New and replaced articles in Webshop

News – new design of non-return valve for bottom filling

Service News 2019/nr 2

Complete equipment for bottom filling

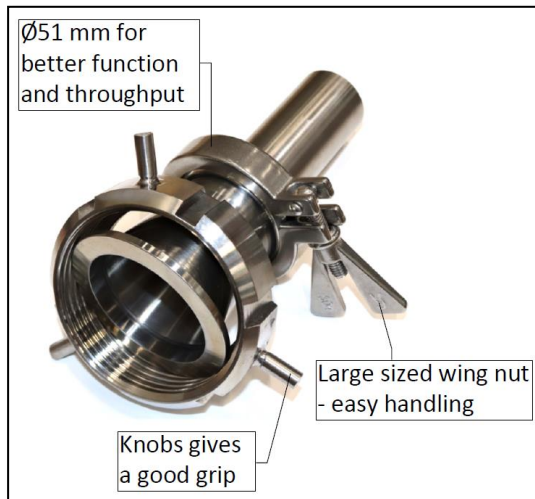
We can now present an improved solution of non-return valve for bottom filling. The pictures below show the complete part and the non-return flap itself.

- The nut towards the tank outlet has been provided with knobs which simplifies assembly and disassembly at the outlet.
- The non-return valve has a new design which improves the function when opening and closing. It has also a bigger dimension, $\varnothing 51$ mm, for improved throughput.
- The non-return valve has a new seat which minimizes the risk for milk residues after cleaning.
- Connection of the hose fitting is now with a clamp with a large sized wing nut which simplifies mounting and dismounting for control and cleaning.

➤ **NEW/REPLACED – Non-return valve for bottom filling SMS 63.5/51 with $\varnothing 38$ mm hose connection $\varnothing 38$ mm**

- 32051852 Non-return valve for bottom filling of milk tank, coupling nut SMS 63.5, hose connection $\varnothing 38$ mm – *replaces 32051552*
- 32051853 Non-return valve for bottom filling of milk tank, coupling nut SMS 51, hose connection $\varnothing 38$ mm – *replaces 32027752*
- 32051856 Non-return valve for bottom filling of milk tank, coupling nut DIN 65, hose connection $\varnothing 38$ mm – *replaces 32029551*
- 32051857 Non-return valve for bottom filling of milk tank, coupling nut DIN 50, hose connection $\varnothing 38$ mm – *replaces 32034451*

➤ **NEW/REPLACED – Time relay**

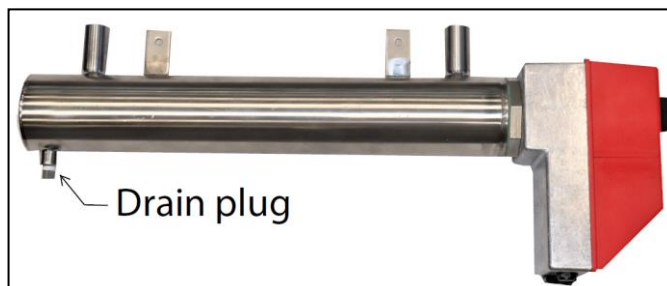
833655 Time relay 1s-100h, 24-240VAC/DC – *replaces 833665*
